STATE OF CONNECTICUT SITING COUNCIL

PETITION OF LSE PHOENIX LLC
FOR A DECLARATORY RULING
THAT NO CERTIFICATE OF ENVIRONMENTAL
COMPATIBILITY AND PUBLIC NEED IS
REQUIRED FOR THE CONSTRUCTION,
OPERATION, AND MAINTENANCE OF
A 1.99 MW AC SOLAR PHOTOVOLTAIC
FACILITY IN NORTH CANAAN, CONNECTICUT

PETITION NO. 1412

**PETITIONER LSE PHOENIX LLC'S RESPONSES TO SITING COUNCIL
INTERROGATORIES SET TWO DATED JULY 1, 2020**

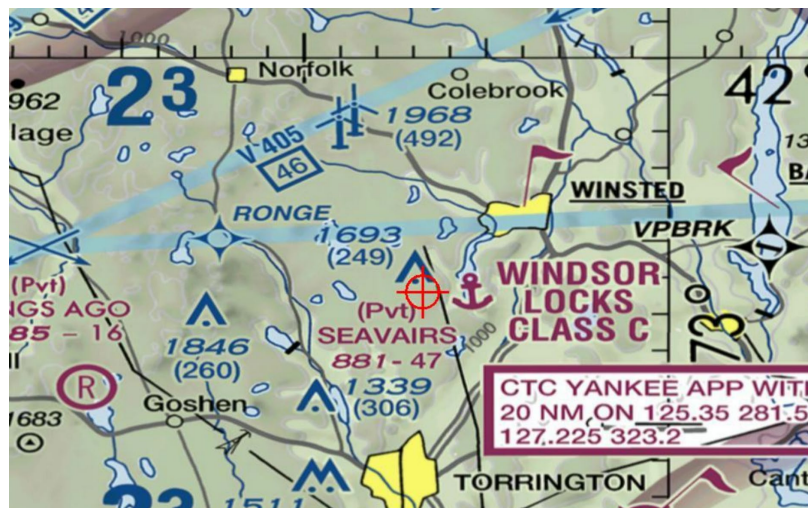
30. Referencing Exhibit 1 of the Petition, Sheet DN-1, would the proposed fence have a wire mesh with six-inch spacing? Referencing page 6 of the Petition, Lodestar notes that the project would include a “...seven and one half (7.5) foot chain-link fence...” Would it be a seven-foot tall (nominal size) fence with a six-inch gap at the bottom of the fence for wildlife passage? Explain.

The fencing will be seven feet tall with a six inch (6”) gap at the bottom for wildlife passage.

Figure 2
Existing Conditions

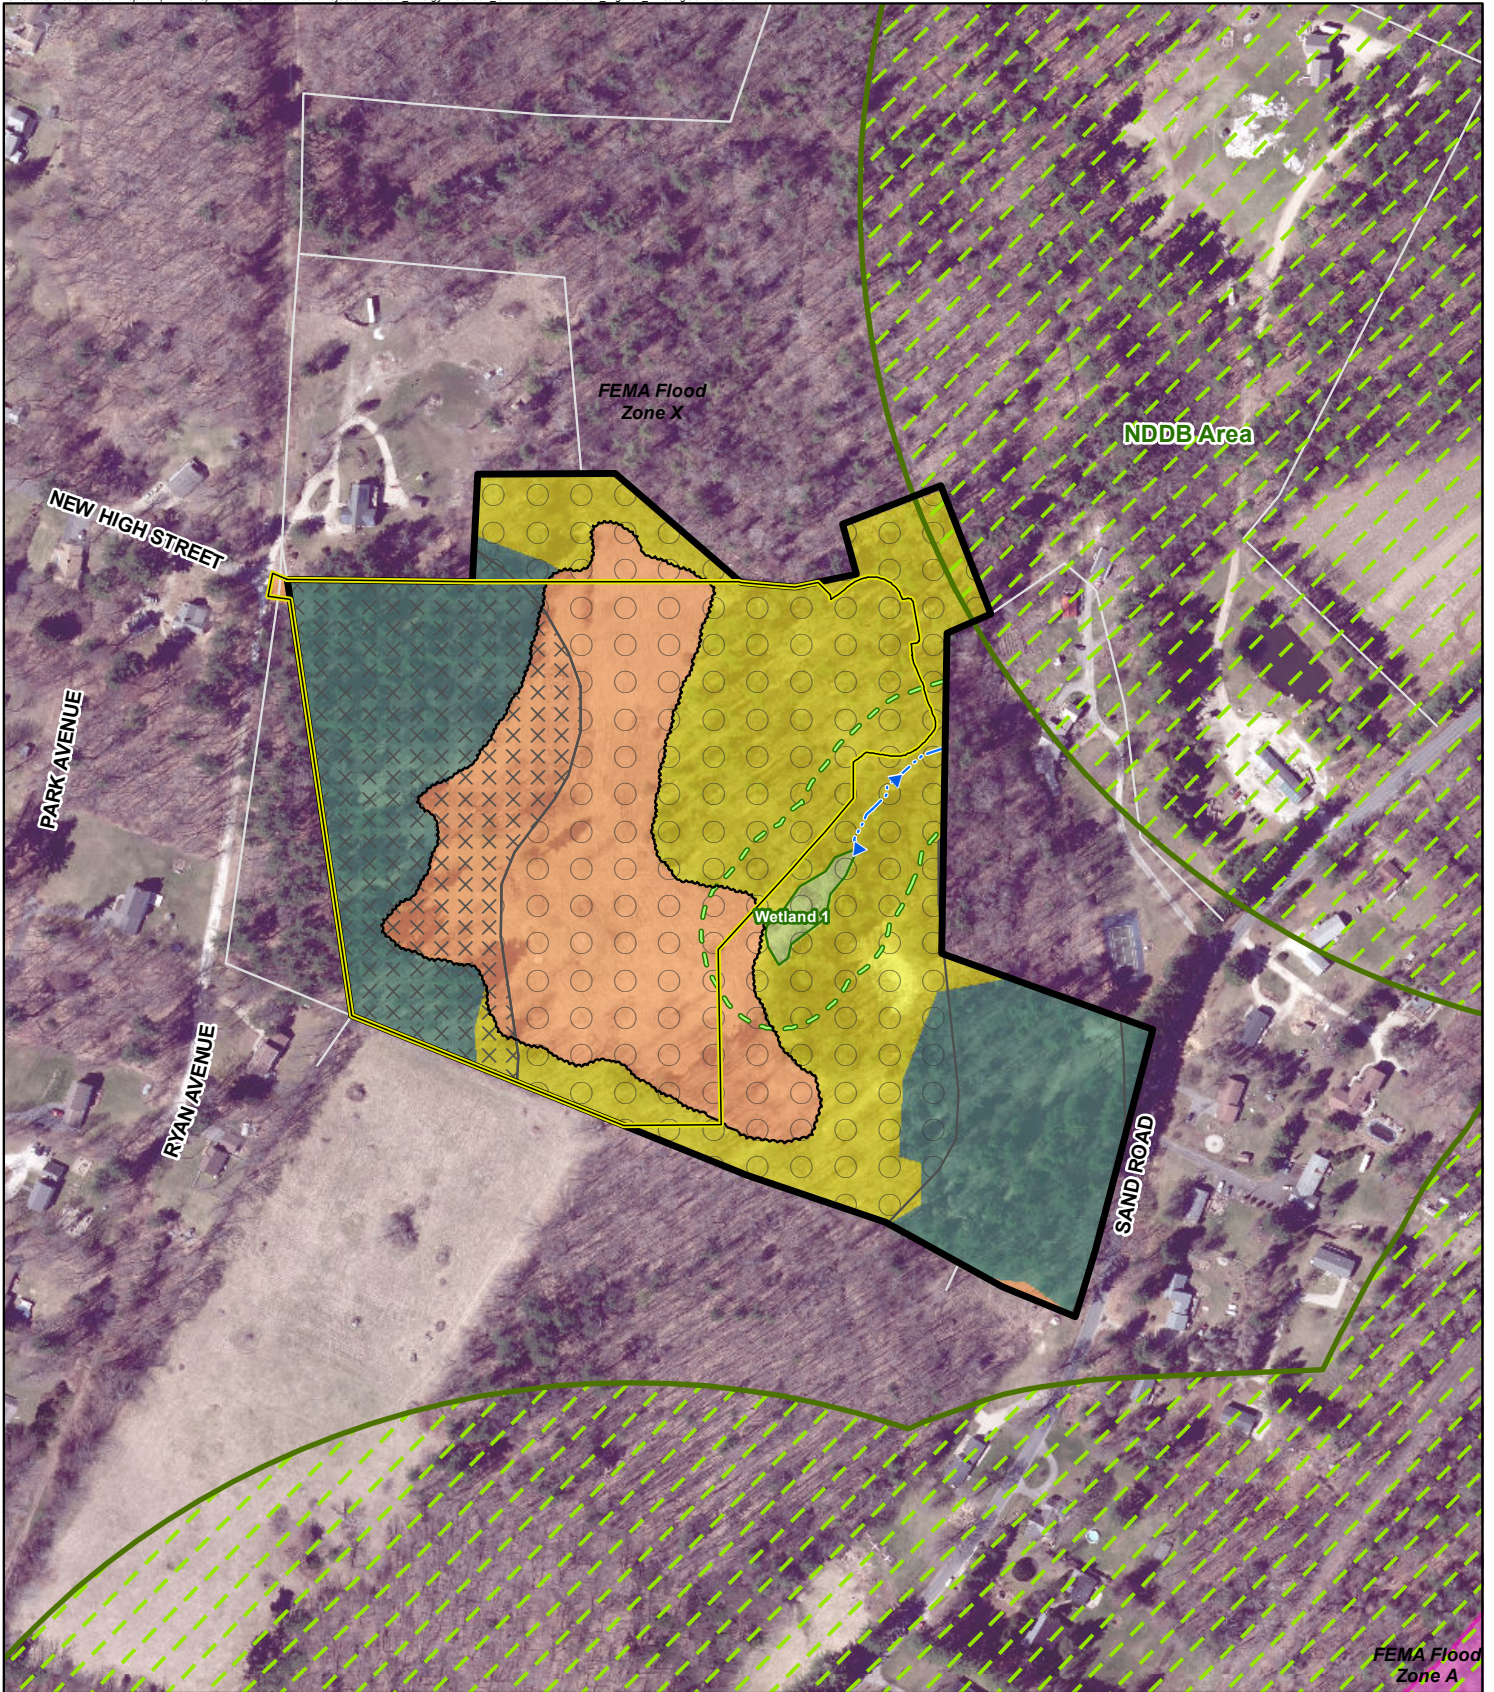
24. Referencing Exhibit 1 of the Petition, Figure 2 – Existing Conditions, the proposed site is located outside of the 100-year flood zone. Referencing Exhibit 1 of the Petition, the Federal Emergency Management Agency (FEMA) flood zone map, is the proposed project located in the FEMA unshaded Zone X, an area outside of the 500-year flood zone?

Yes, the Project is located entirely within Zone X and is outside the influence of both a 100-year and 500-year flood zone.

**Figure 4
 Proposed Conditions**

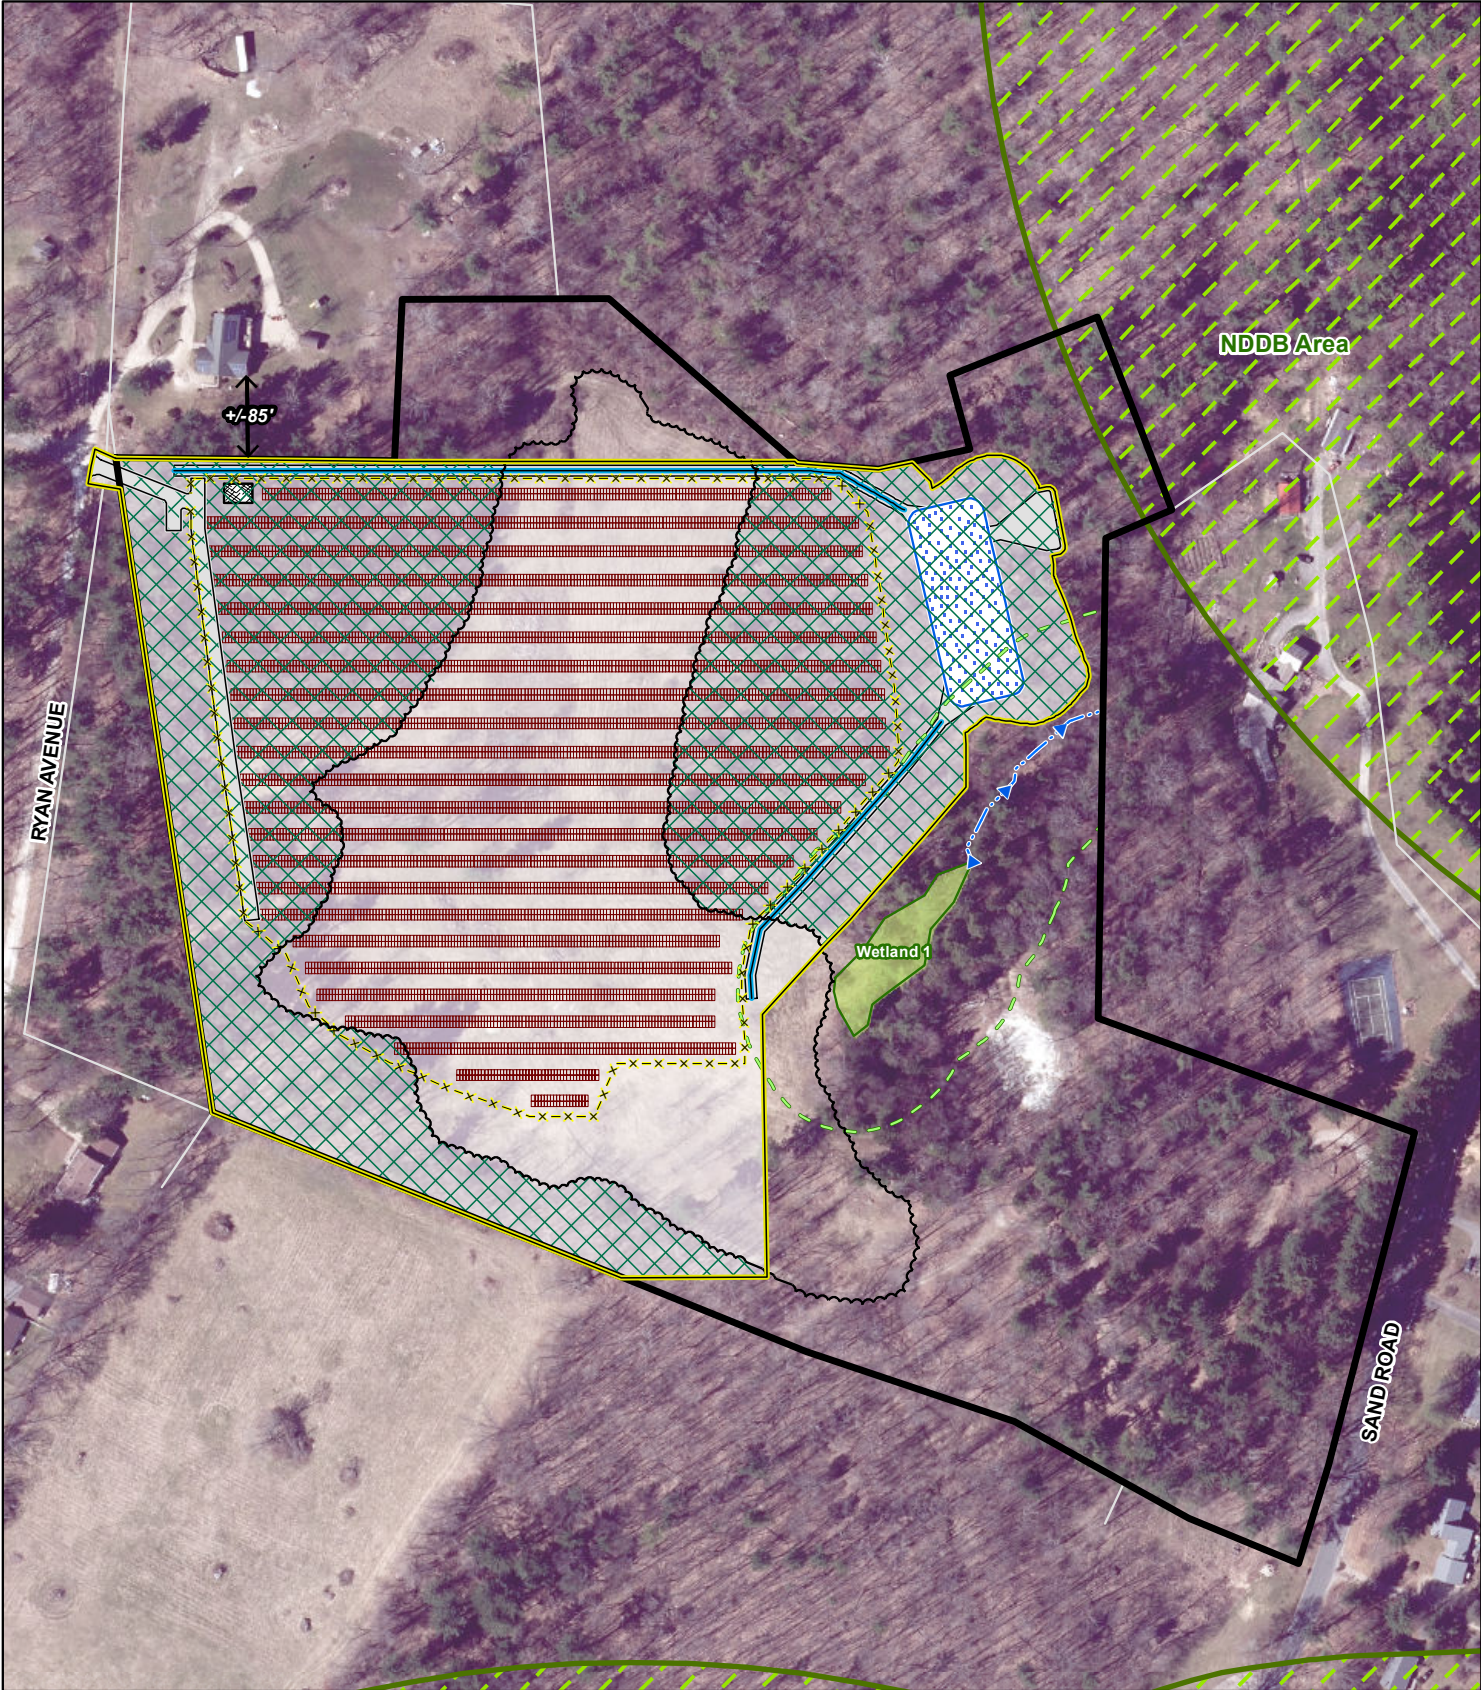
34. Referencing Exhibit 1 of the Petition, Figure 2 – Existing Conditions, can a similar figure be provided as Proposed Conditions, i.e. Figure 2 with the proposed project depicted?

Please see Exhibit B attached hereto.

Figure 3
Existing Contiguous Forest

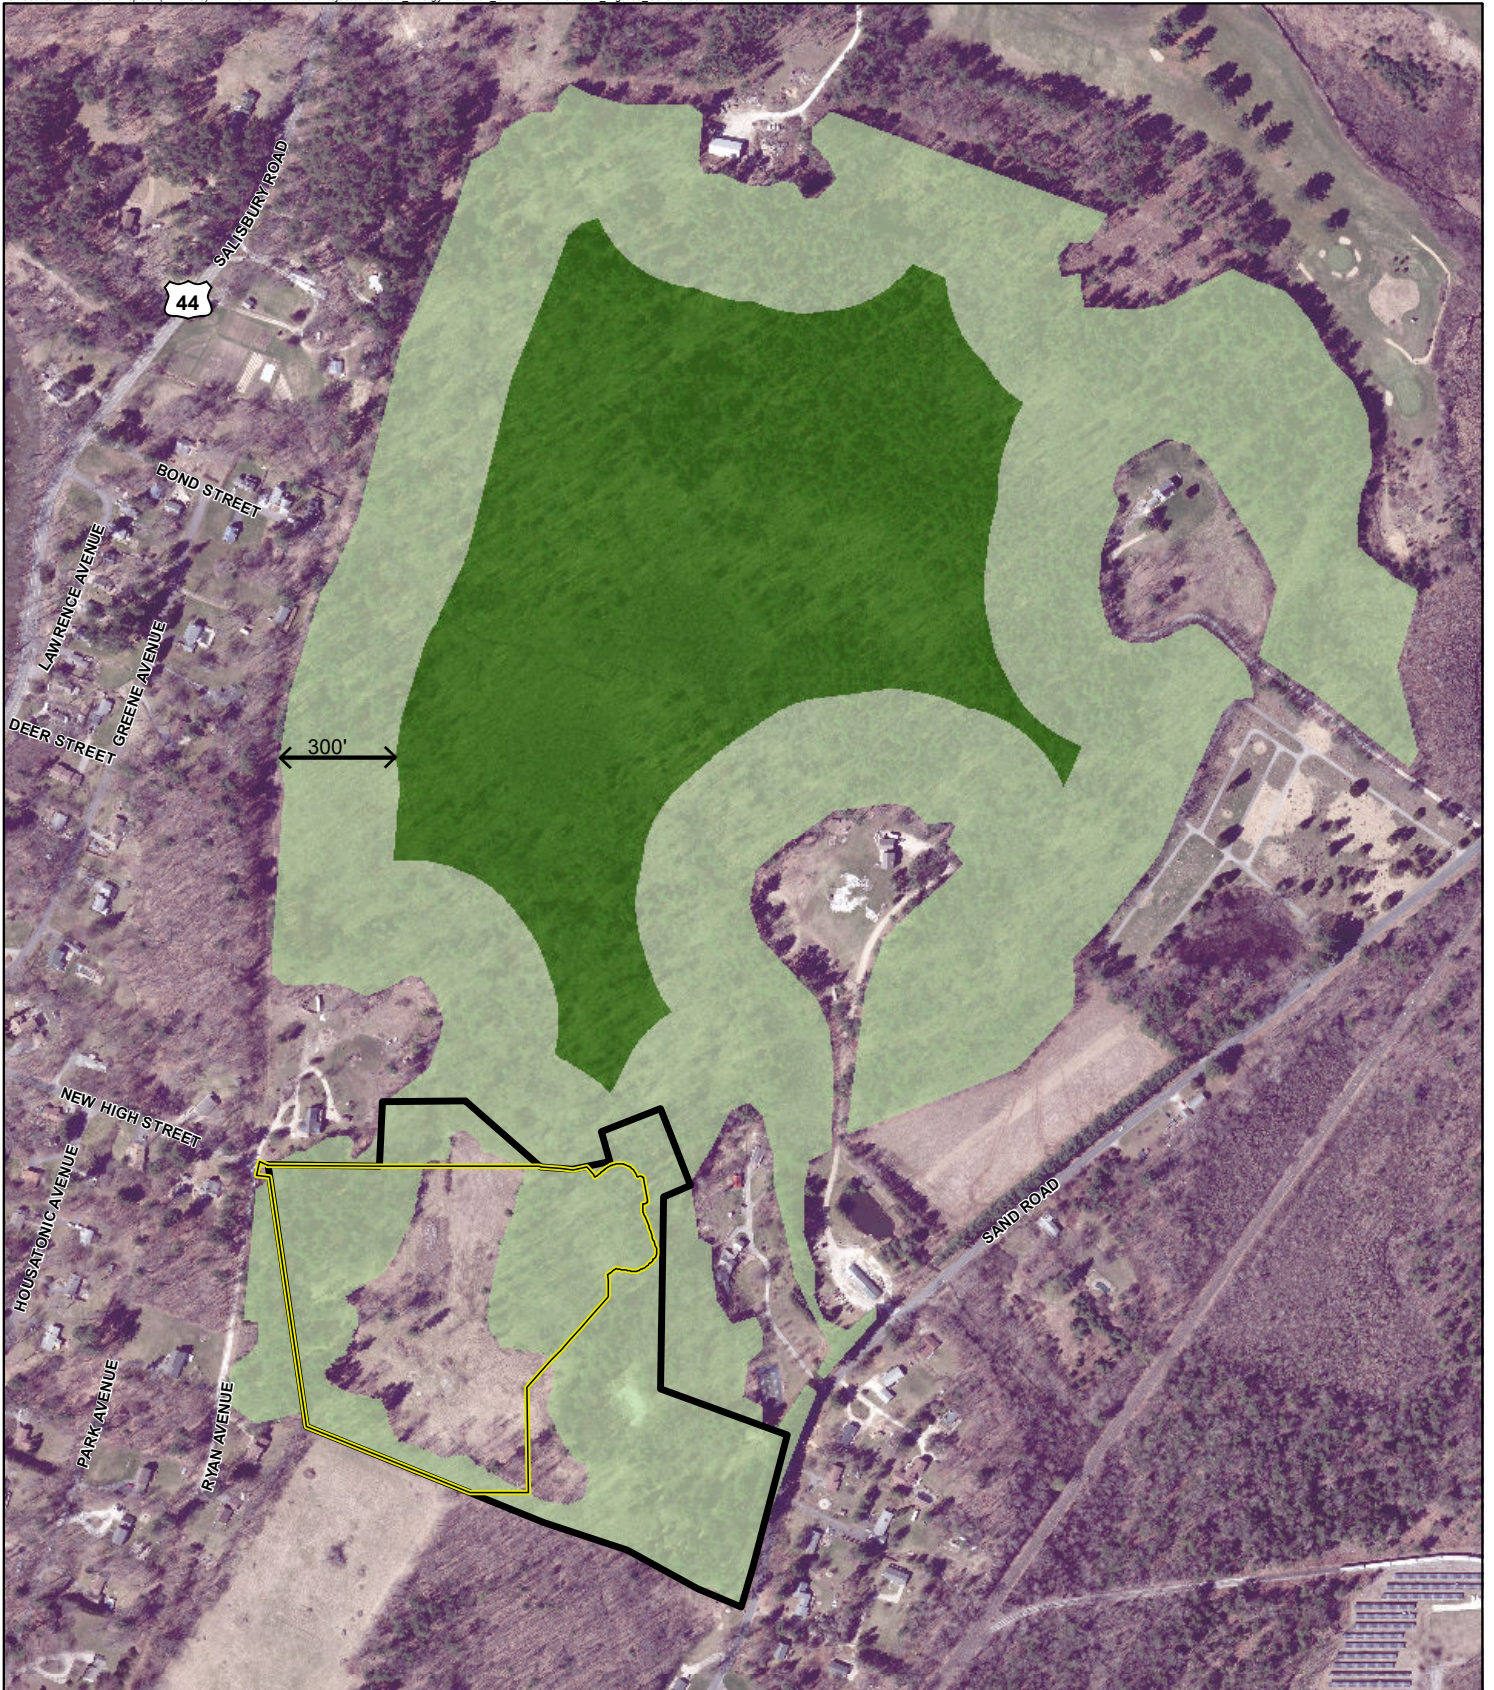
37. Under Connecticut General Statutes §16-50k, "Core forest" means unfragmented forest land that is three hundred feet or greater from the boundary between forest land and nonforest land, as determined by the Commissioner of Energy and Environmental Protection." Would any tree clearing occur within core forest? If so, how many acres? How would tree clearing affect the acreage of core forest and core forest edge? Provide an aerial photograph that depicts pre- and post-construction acreage of core and edge forest.

No tree clearing will occur within core forest. All the forest on the Site is considered edge forest. Referring to the attached graphics in Exhibit C, approximately 9.4 acres of edge forest will be

removed to accommodate construction of the facility. Approximately 0.1 acre of core forest would be impacted, as this area would be converted to edge forest habitat.

Adjacent Recreational Areas and Scenic Roads

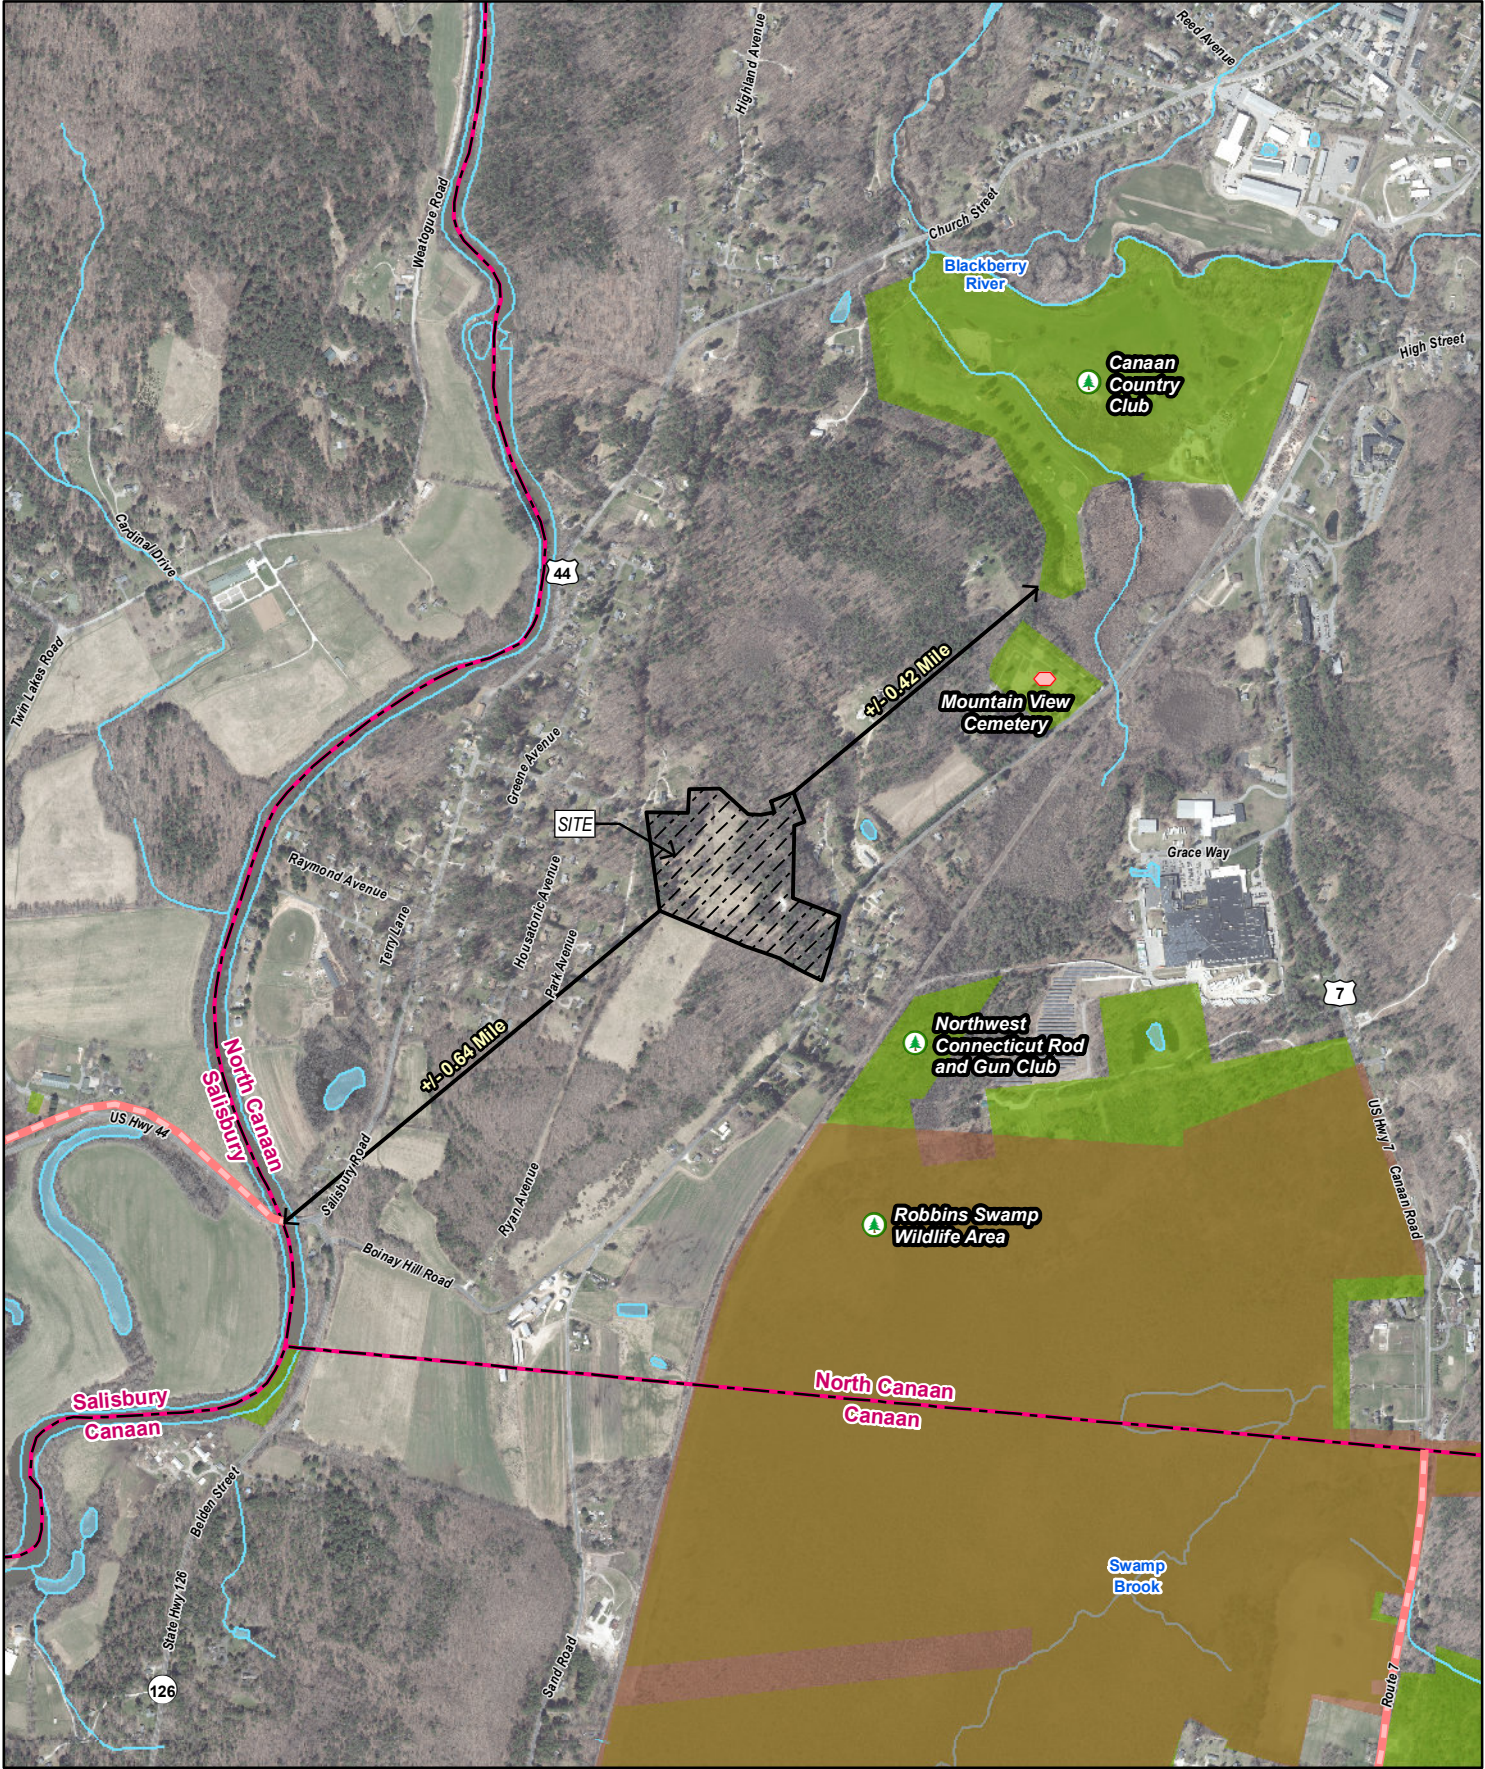
45. Where is the nearest recreational area from the proposed site? Describe the visibility of the proposed project from this recreational area.

46. Where is the nearest national, state and/or locally-designated scenic road from the proposed site? Describe the visibility of the proposed project from the nearby scenic road.

The nearest recreation area from the proposed site is Canaan Country Club, approximately 0.42 miles to the northeast. See Exhibit D attached hereto, Adjacent Recreation Areas and Scenic Roads figure. The existing topography and surrounding wooded areas will limit visibility of the Project from the Canaan Country Club.

The nearest scenic road to the proposed site appears to be U.S. Route 44 in Salisbury, CT, approximately 0.64 miles to the southwest. See Exhibit D, Adjacent Recreation Areas and Scenic Roads Figure. The existing topography and surrounding wooded areas will limit visibility of the Project from U.S. Route 44.
